CITY OF BOULDER
AGENDA ITEM PLANNING BOARD
MEETING DATE: October 24, 2013

Public hearing for consideration of Site Review application LUR2013-00033 to redevelop the former Boulder County fire training center site into 31 single family homes with a mixture of attached and detached garages. The units are proposed to range from approximately 2,060 to 3,940 square feet in area. The project includes the extension of Zamia Avenue to the east and the construction of 10th Street as a connection from Yellow Pine Avenue to Lee Hill Drive.

Project Name: 820 Lee Hill Drive Site Review

SITE REVIEW CORRECTIONS

A1.1 House

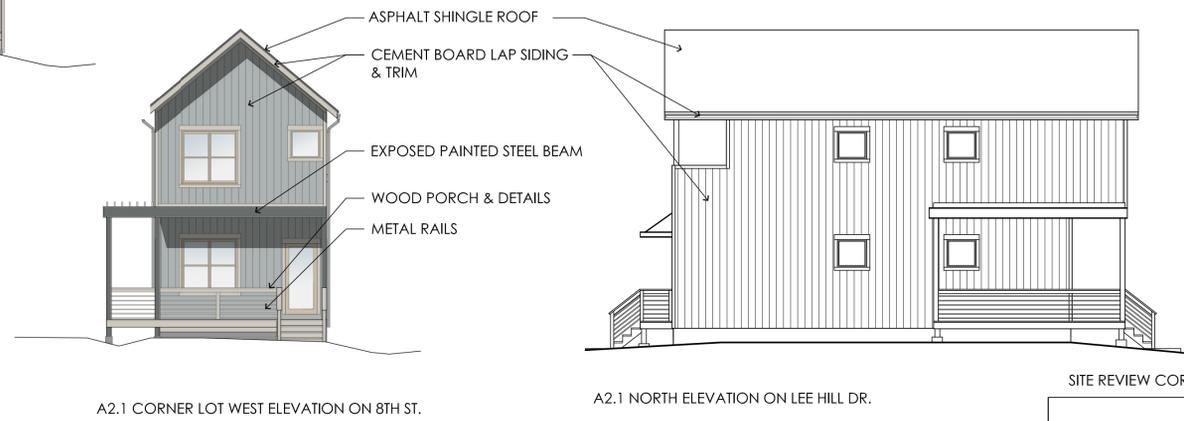
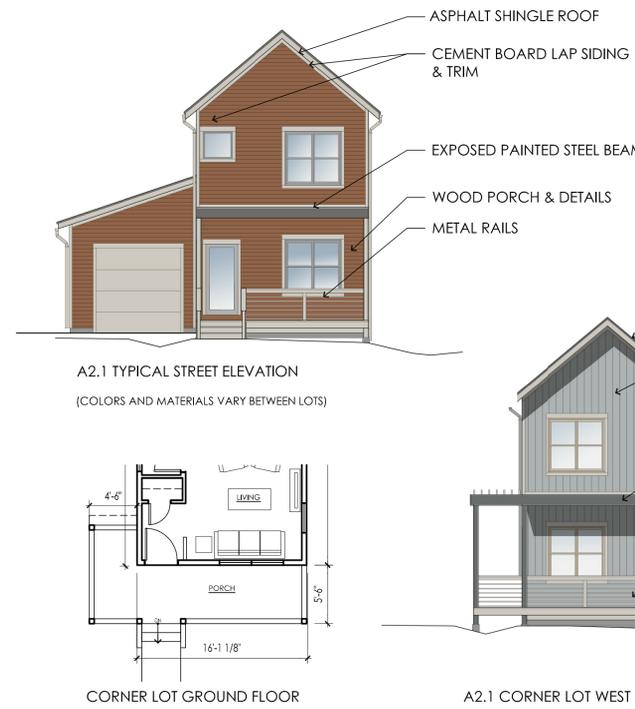
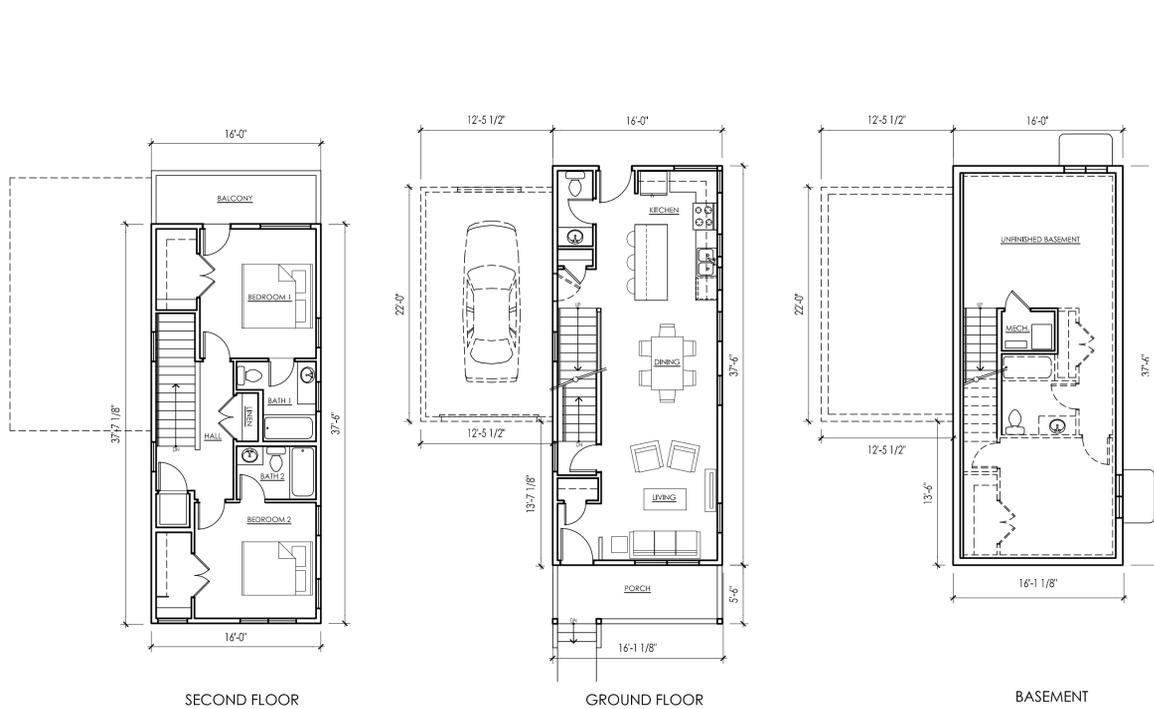
7. The proposed architecture and materials for model type A2.1 do not appear to meet the site review criteria. Variation in the building materials will help breakdown the large expanses of lap siding as well as add variation in the building form. Consideration should be given to utilizing more pedestrian scale materials and architectural detailing.

C1.0
PRELIMINARY
GRADING
& DRAINAGE
PLAN
09.27.13

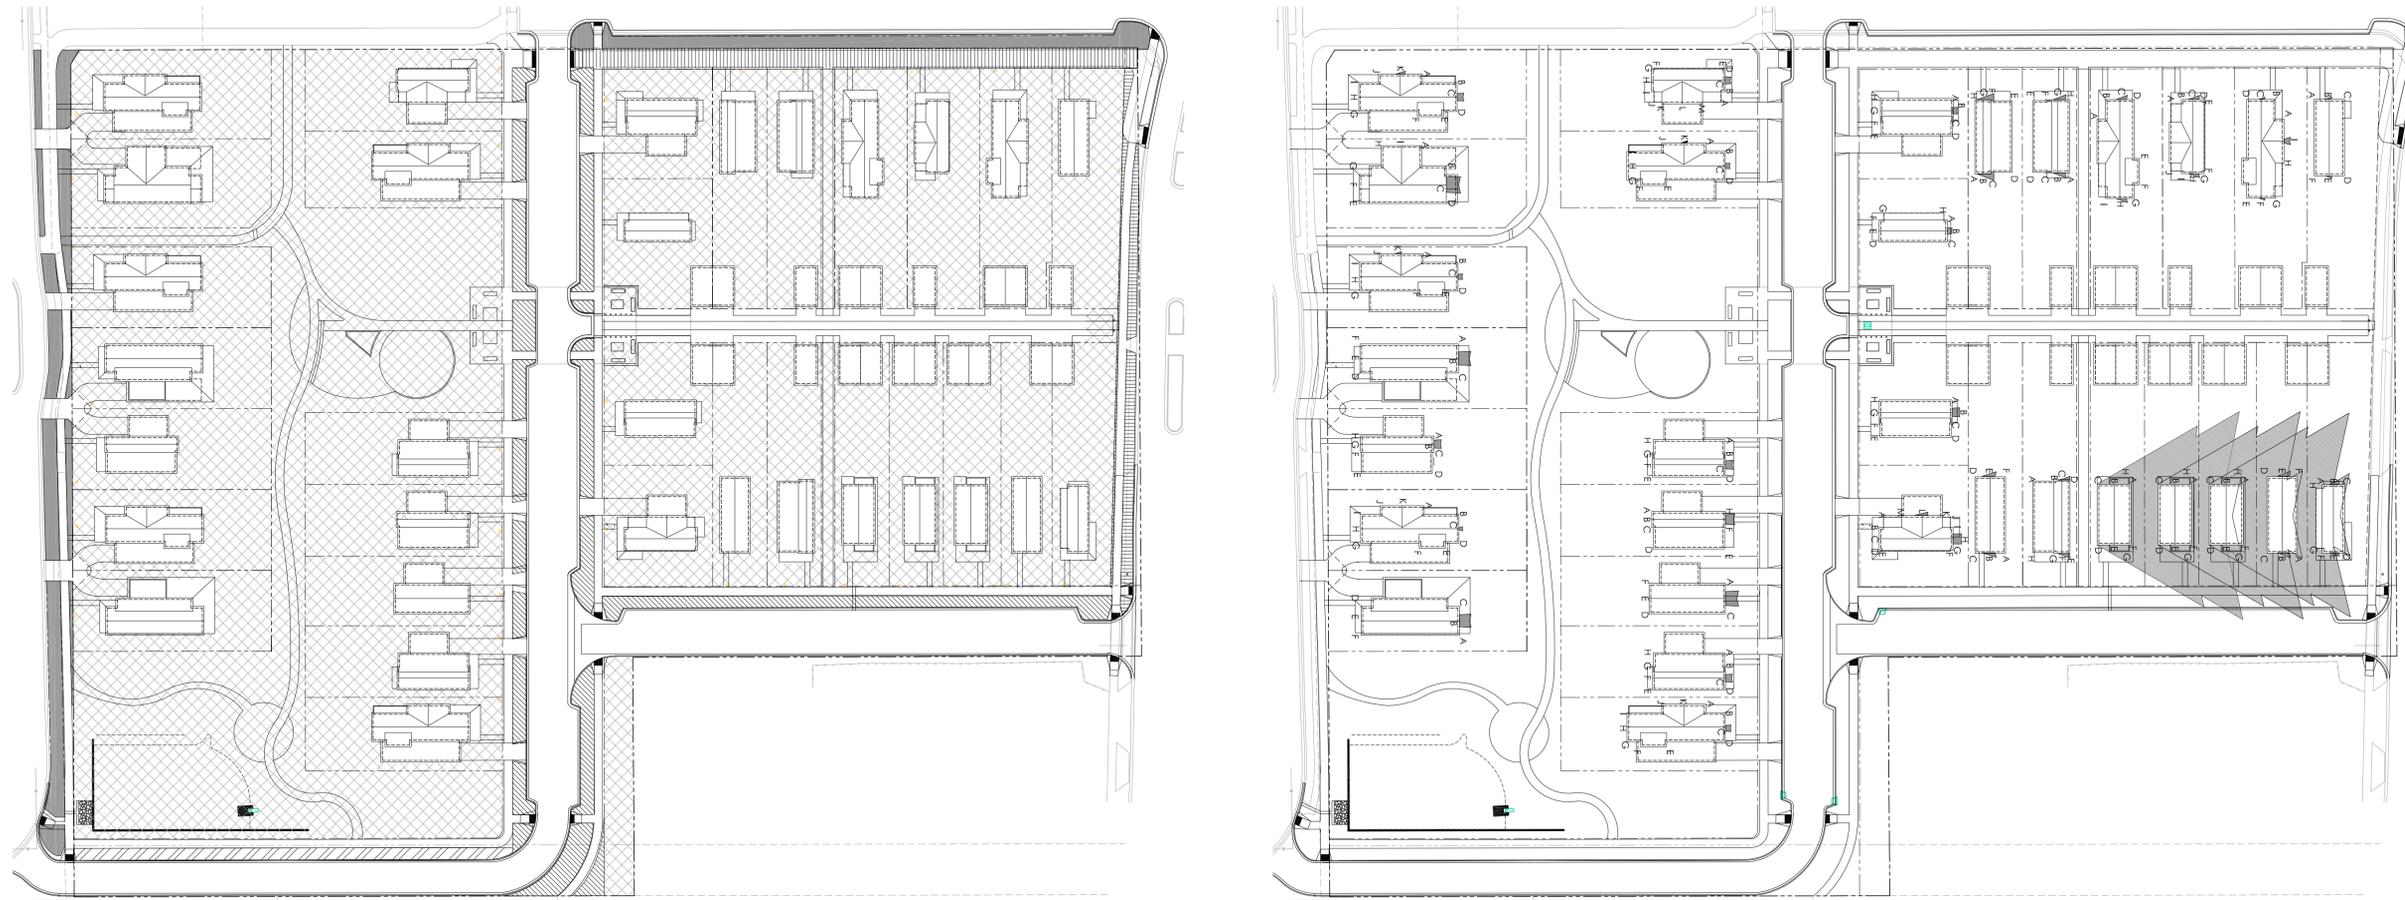
14. Page C1.0 (Preliminary Grading and Drainage Plan) labels the north-south street connection as both 9th and 10th Street. Please revise accordingly.

Appendix 1: Ground Truth of Context Setback Study Prepared by Coburn Associates

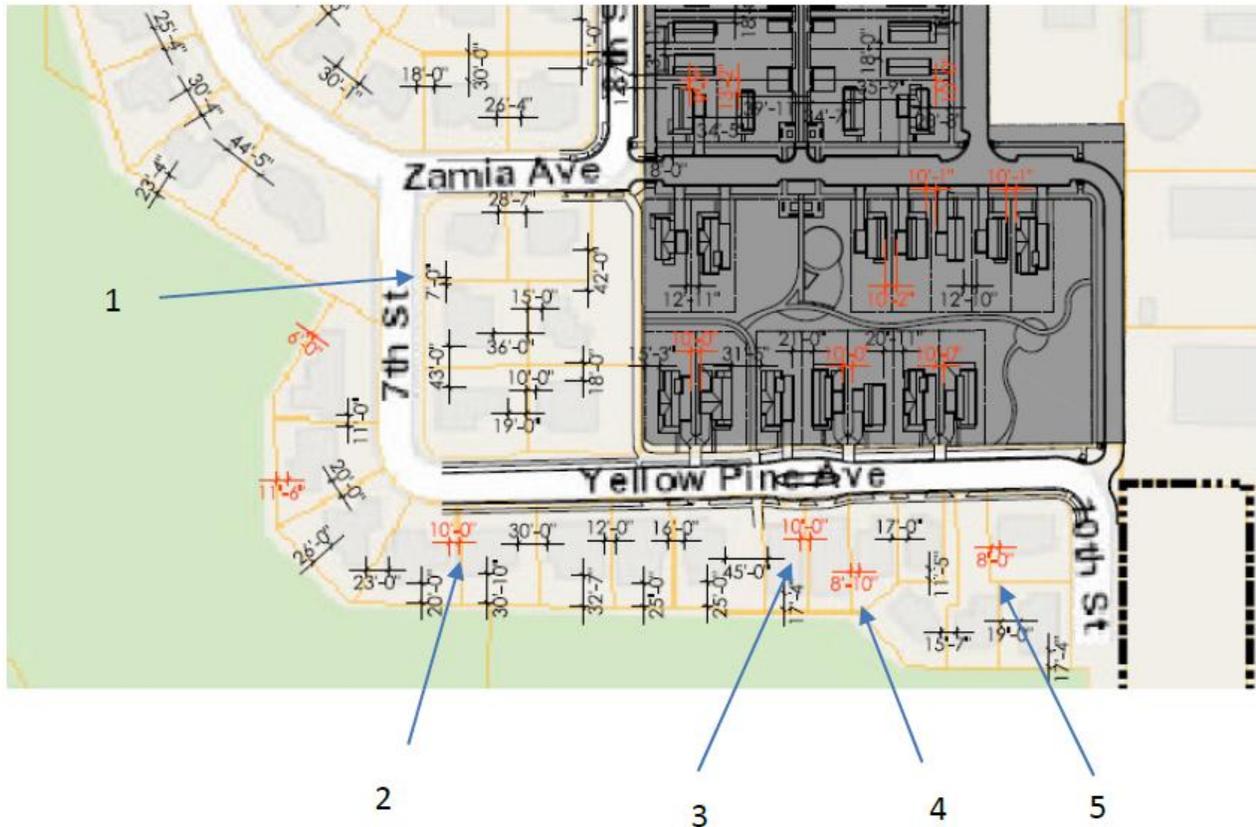
Closest distance between houses were manually measured, for houses in North Briar that Coburn is asserting are at or below the setback distance in their variance request (10 feet).

1. 28 feet (Coburn estimate is 7 feet)
2. 15 feet (Coburn estimate is 10 feet)
3. 15 feet (Coburn estimate is 10 feet)
4. 15 feet (Coburn estimate is 8 feet 10 inches)
5. 65 feet (Coburn estimate is 8 feet)

Fig 1. 10th Street – Current Street Elevation

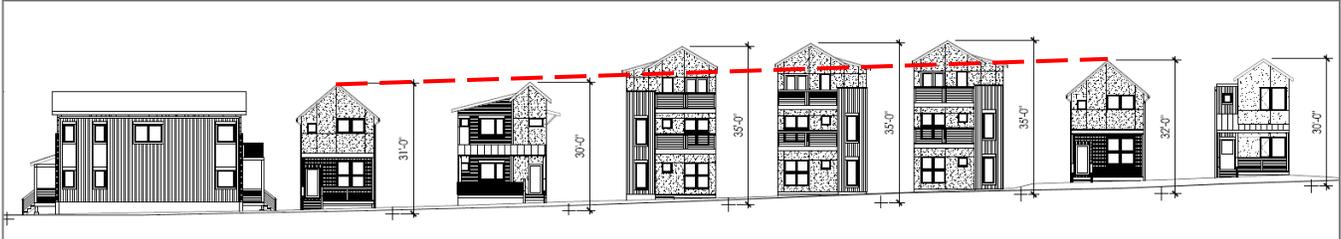
- As shown in figure 2, consider diversifying the model types and architecture of homes located along 10th Street to create interest and minimize perceived density. Staff appreciates efforts to locate larger models on the interior of the site; however the three larger homes (model B4) located in a row create an imposing presence (see below). The applicant should consider a greater roof pitch on these models to lessen the perceived height and scale.
